## ArevaEPRDCPEm Resource

Attached is a DRAFT response for Question 07.01-35 of RAI No. 505 (FSAR Ch. 7) provided in the attached file in advance of the May 30, 2012 final date.

All indicated changes are in response to RAI 505, 07.01-35

Figure 7.3-63—Fuel Pool Area Fuel Handling Accident

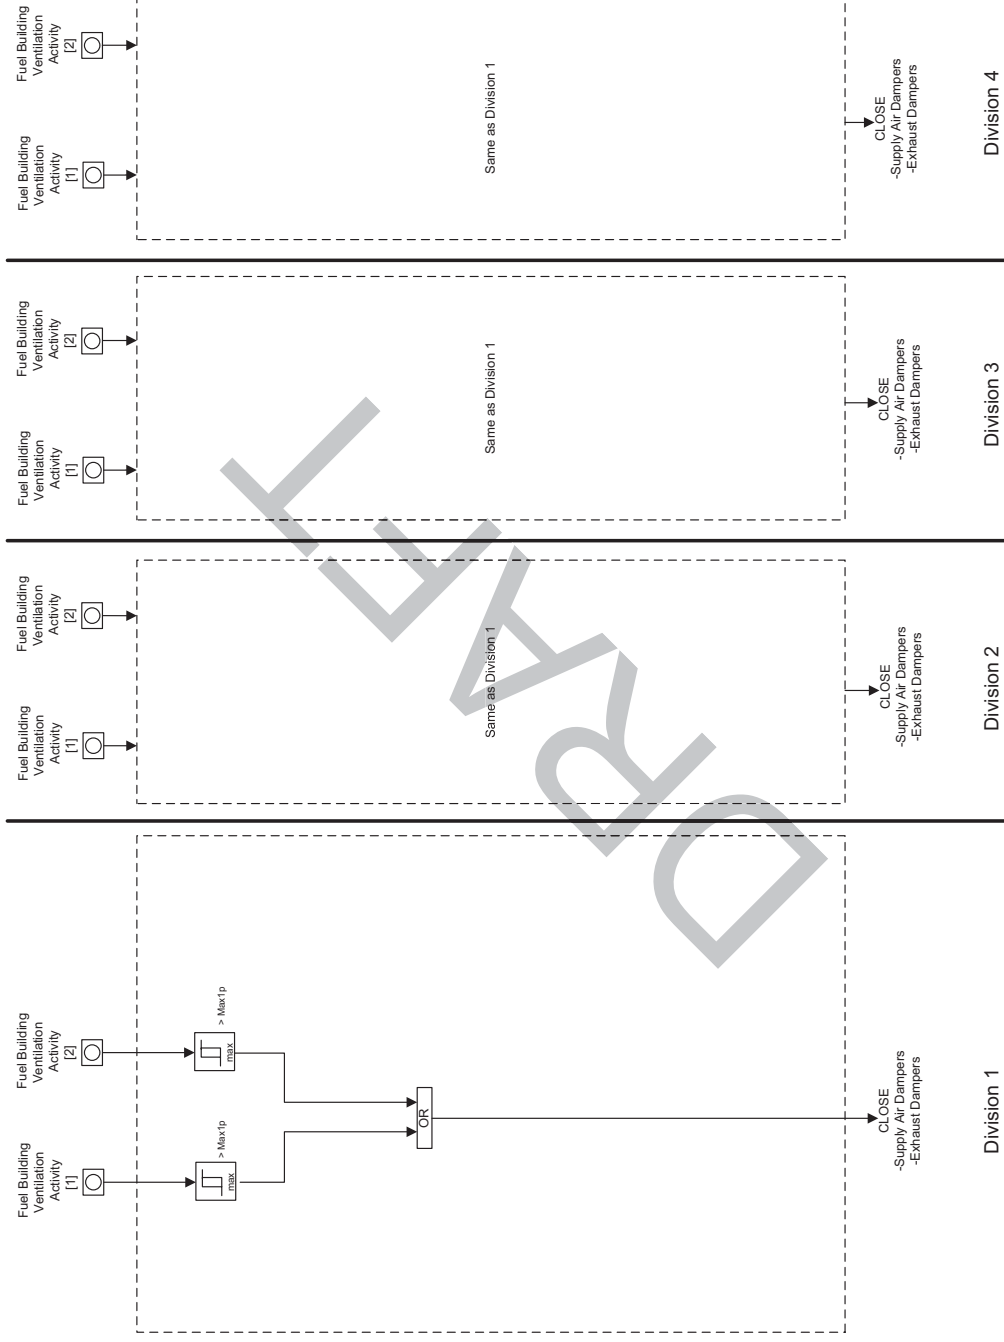
All indicated changes are in response to RAI 505, 07.01-35

Figure 7.3-64—Reactor Building Fuel Handling Accident

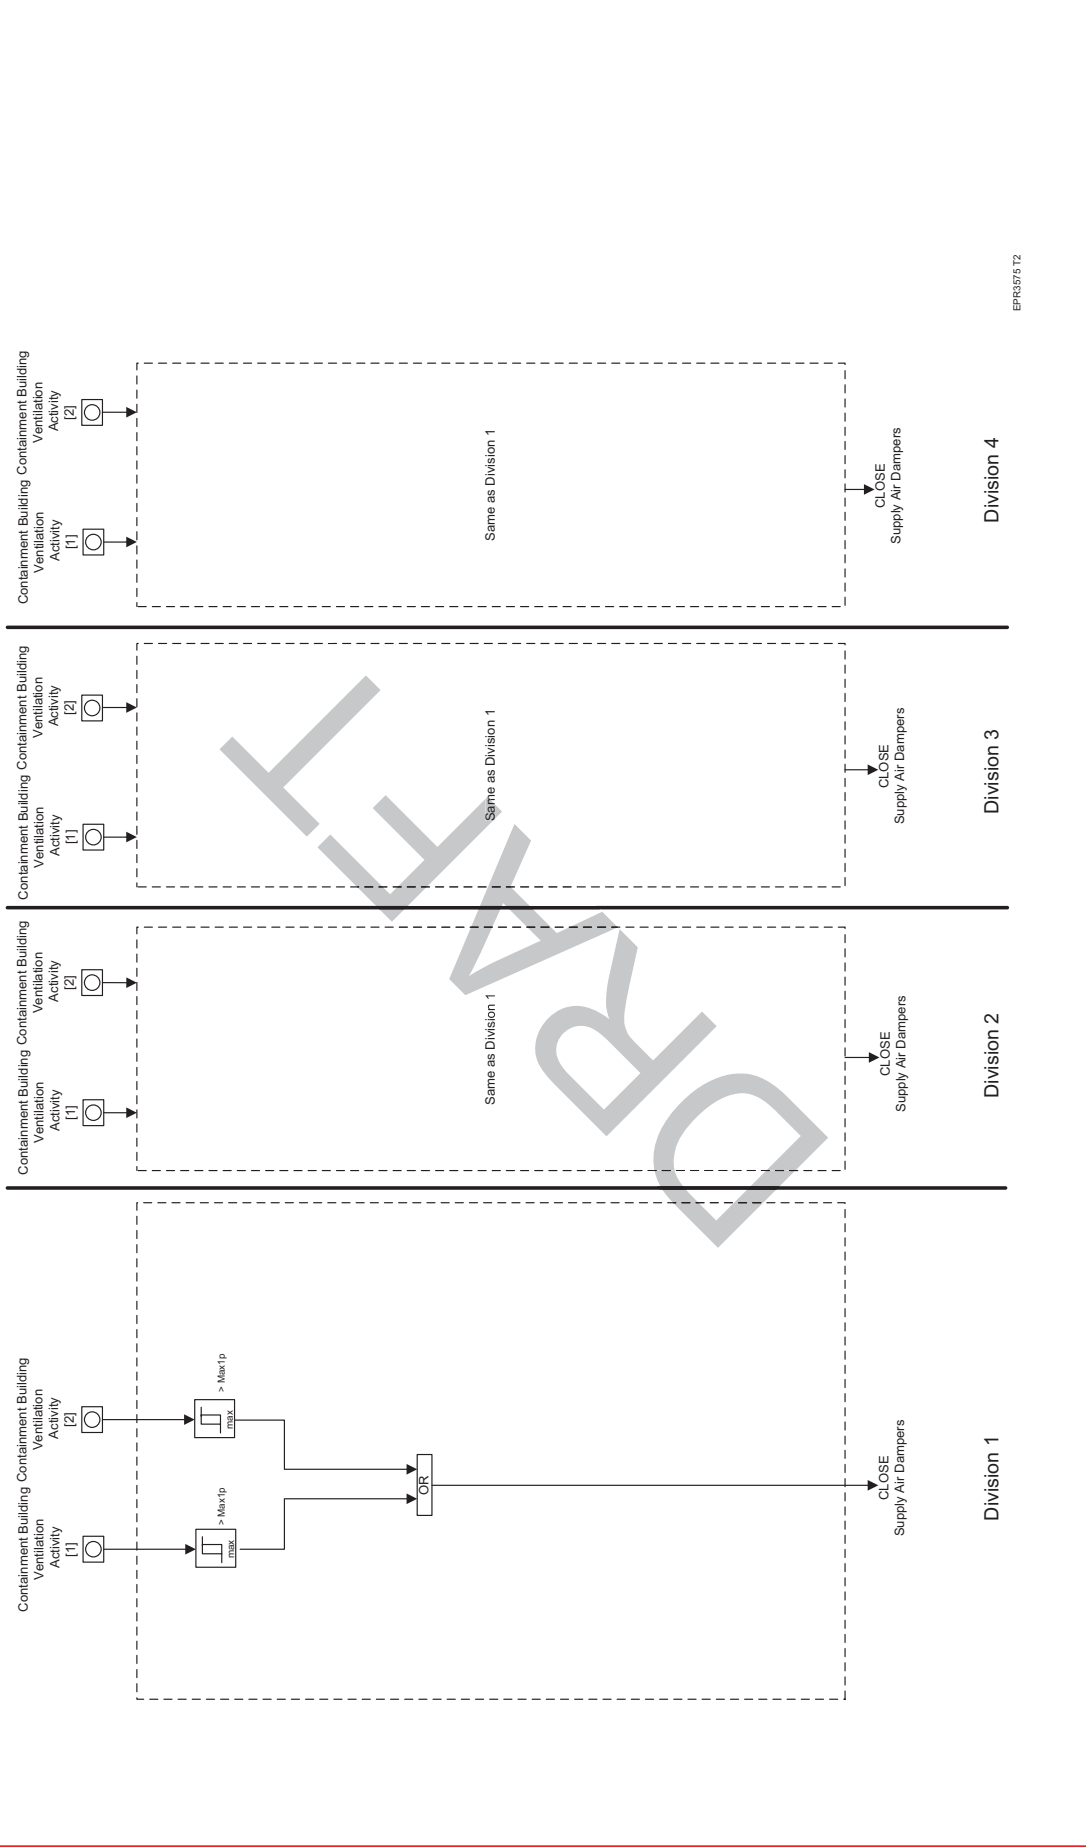
All indicated changes are in response to RAI 505, 07.01-35

Figure 7.6-2—CCWS RCP Thermal Barrier Containment Isolation Valves Interlock

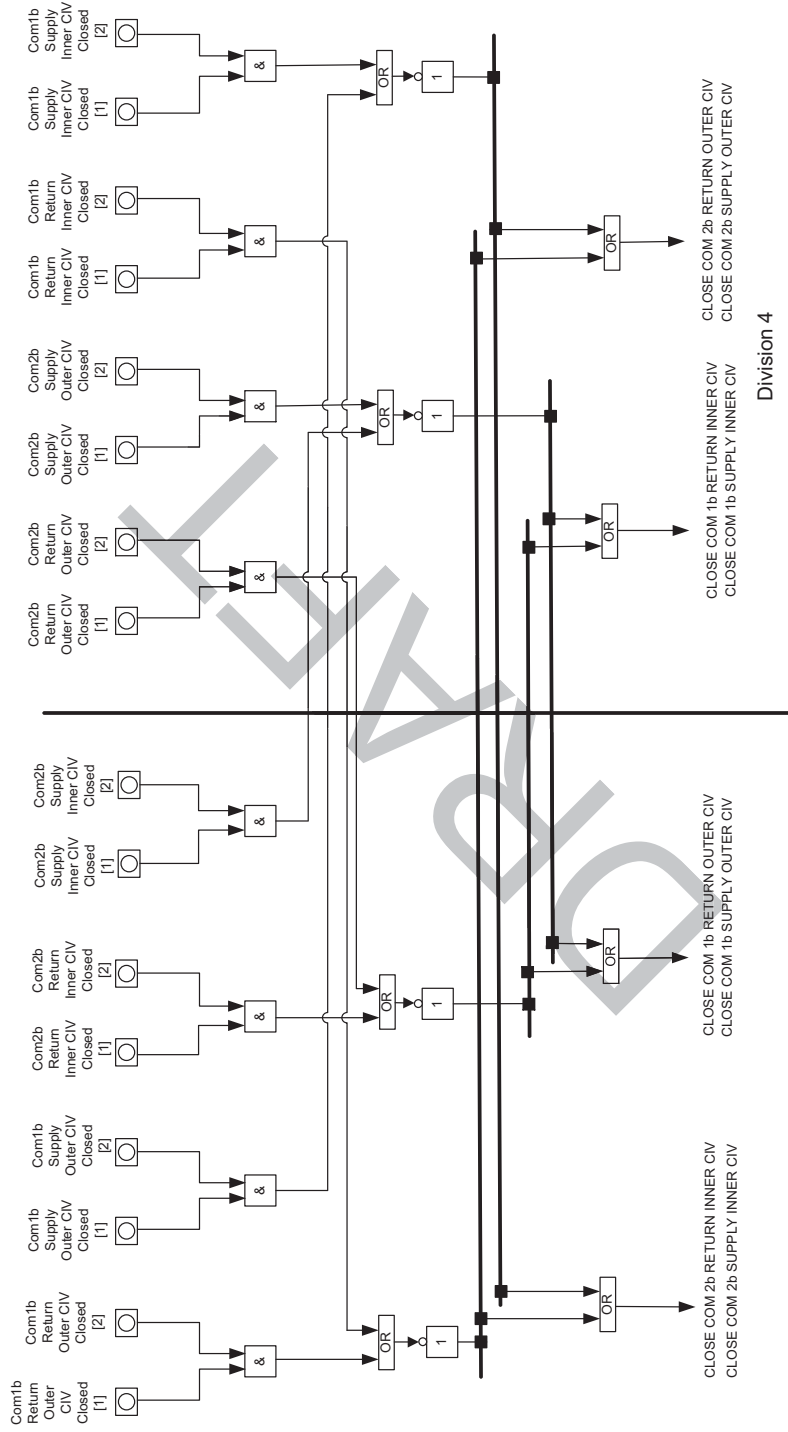
All indicated changes are in response to RAI 505, 07.01-35

Figure 7.6-3—Detection of RHR Connected Interlock

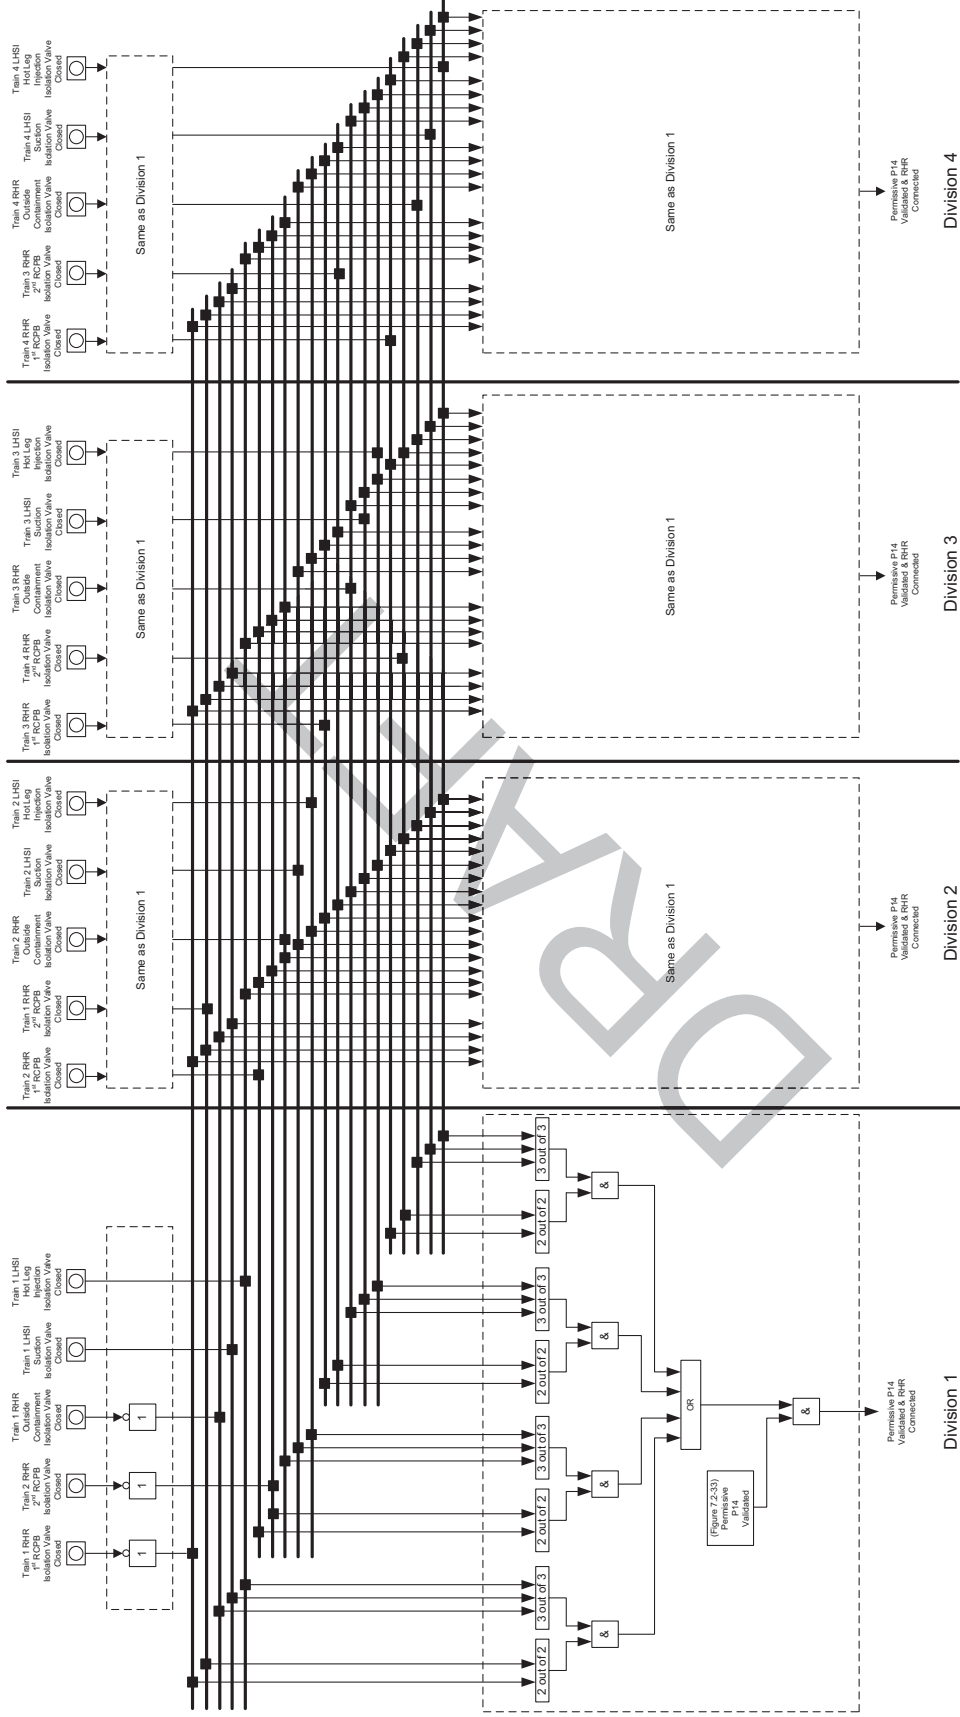
All indicated changes are in response to RAI 505, 07.01-35

Figure 7.6.4—IRWSTS Boundary Isolation for Preserving IRWST Water Inventory Interlock

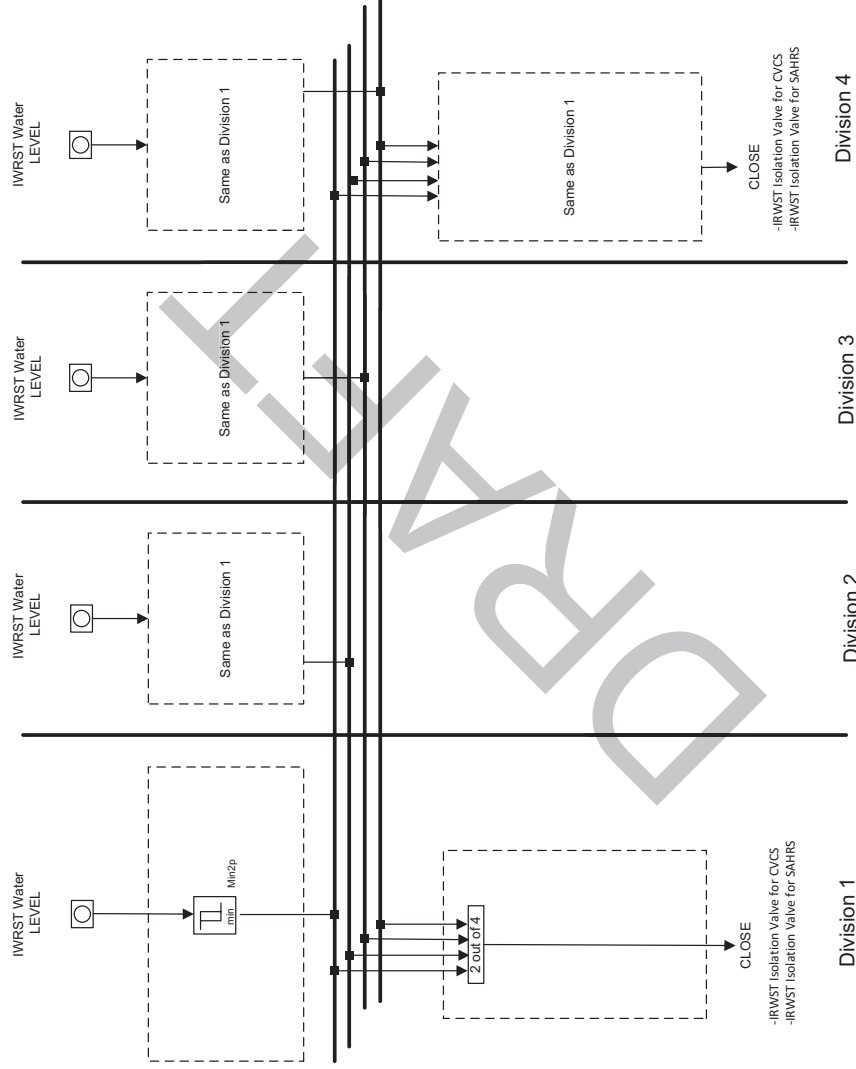
All indicated changes are in response to RAI 505, 07.01-35

Figure 7.6-5—SCWS Train 1 to Train 2 Switchover on Train 1 Low Evaporator Flow / Chiller Blackbox Internal Fault / SCWS Chiller Evaporator Water Flow Control / LOOP Re-Start Failure Interlock

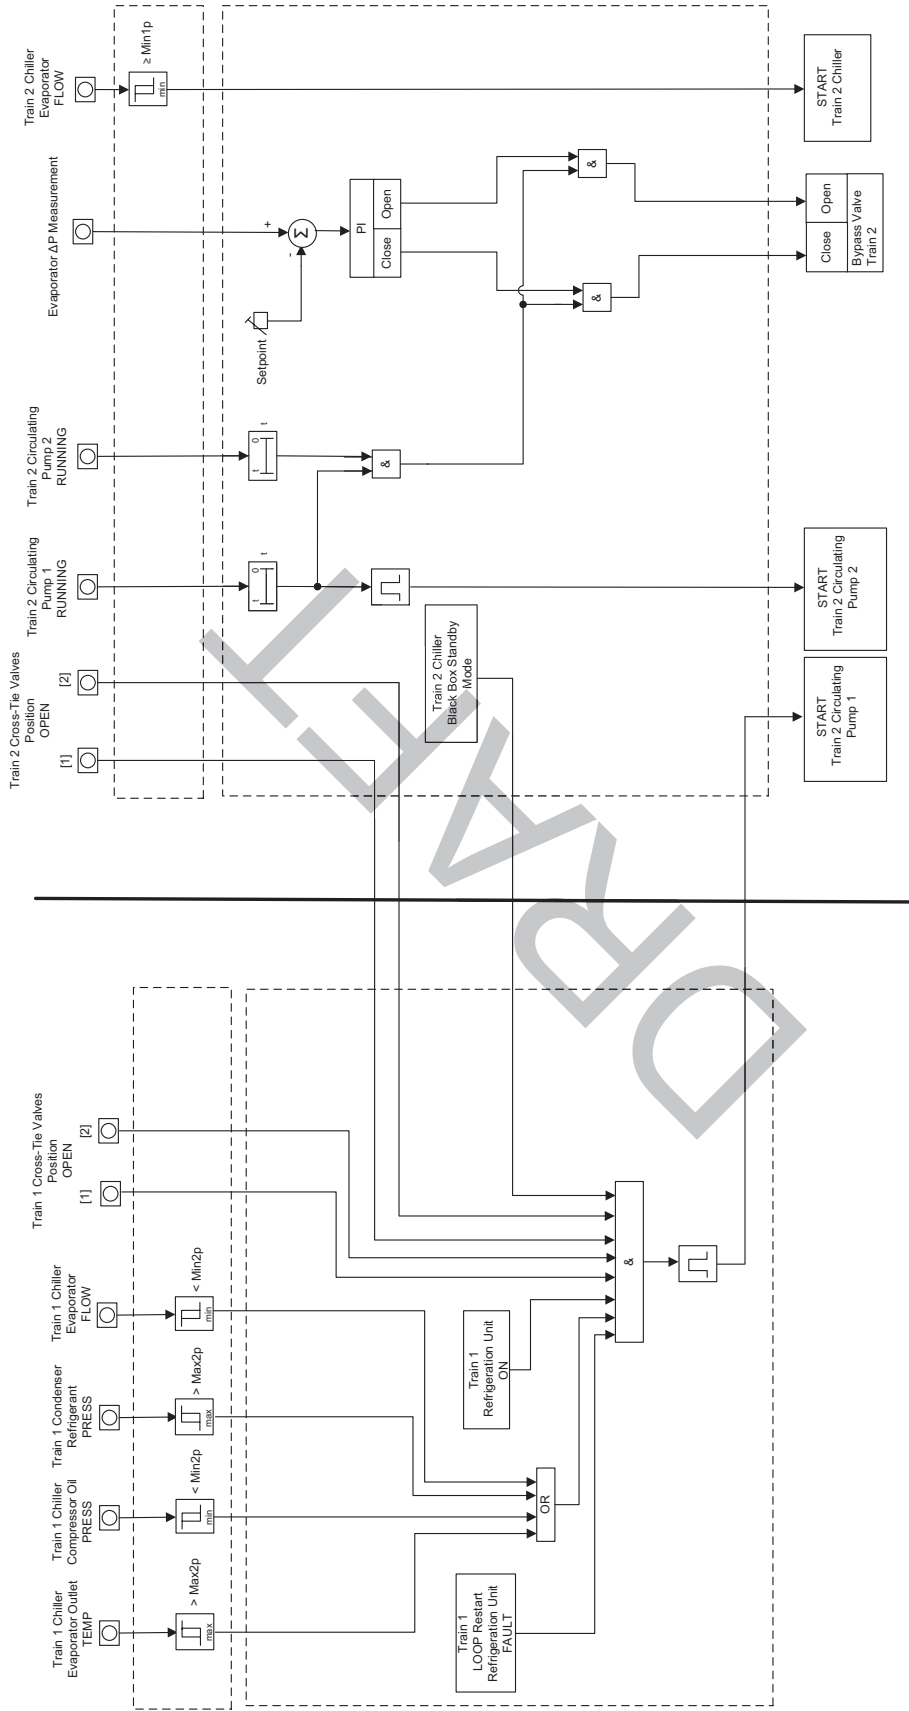
All indicated changes are in response to RAI 505, 07.01-35

**Figure 7.6-6—SCWS Train 2 to Train 1 Switchover on Train 2 Low Evaporator Flow / Chiller Blackbox Internal Fault / Loss of UHS-CCWS / SCWS Chiller Evaporator Water Flow Control / LOOP Re-Start Failure Interlock**

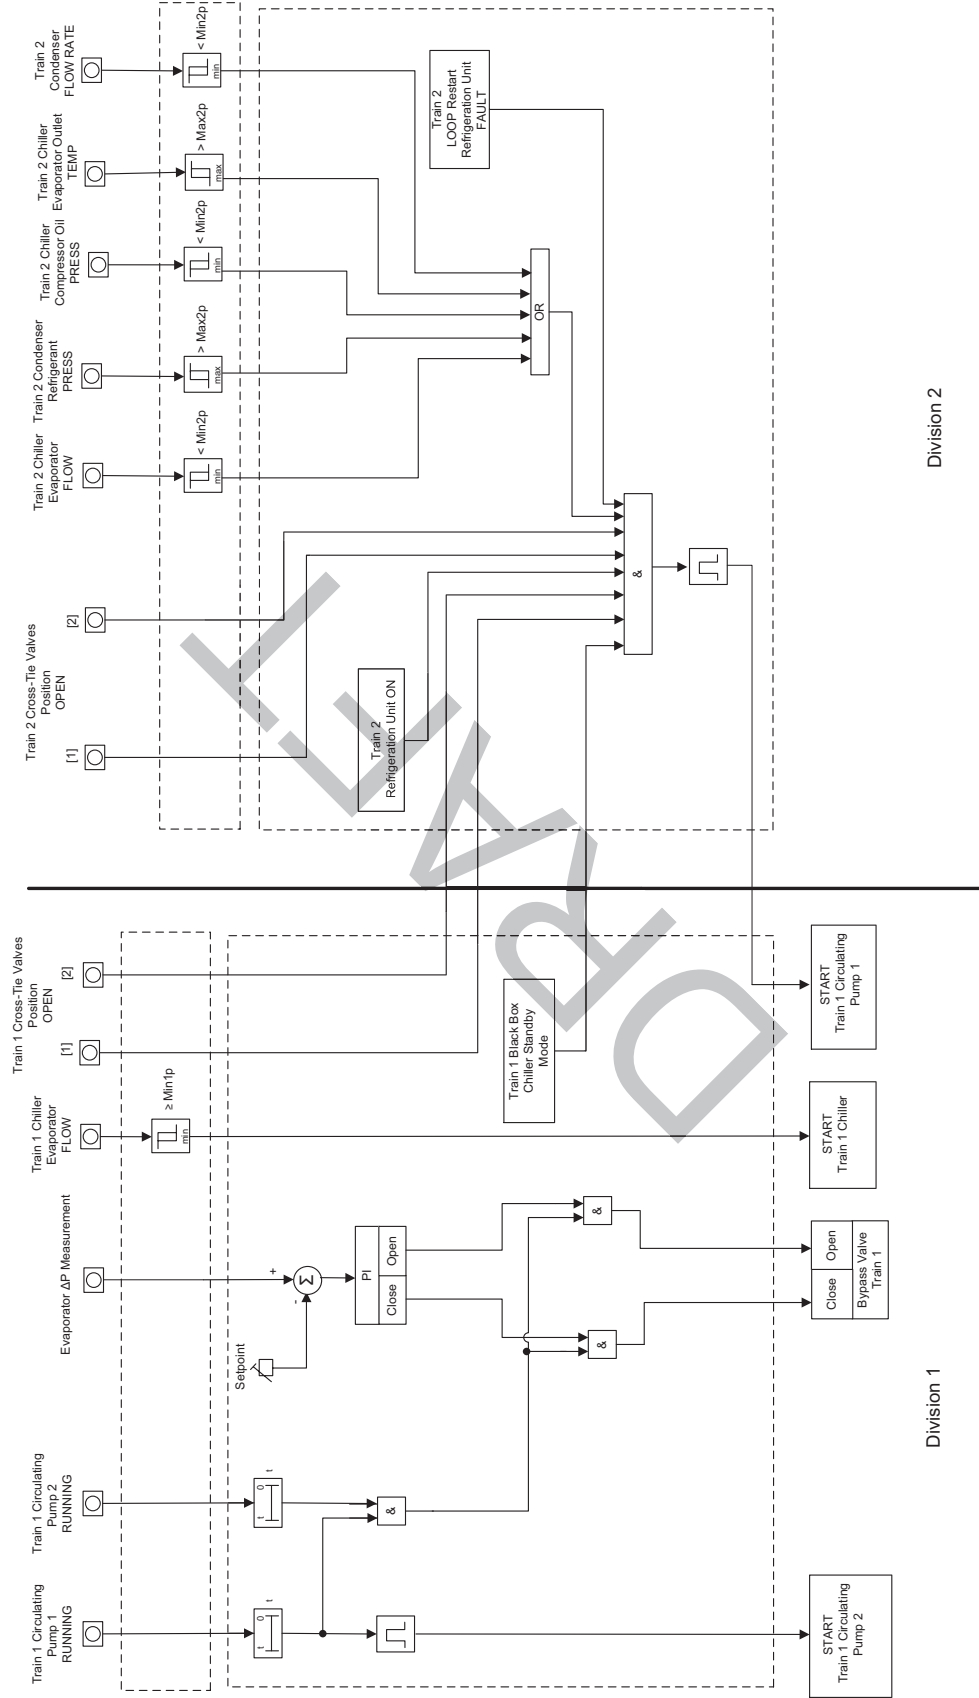
All indicated changes are in response to RAI 505, 07.01-35
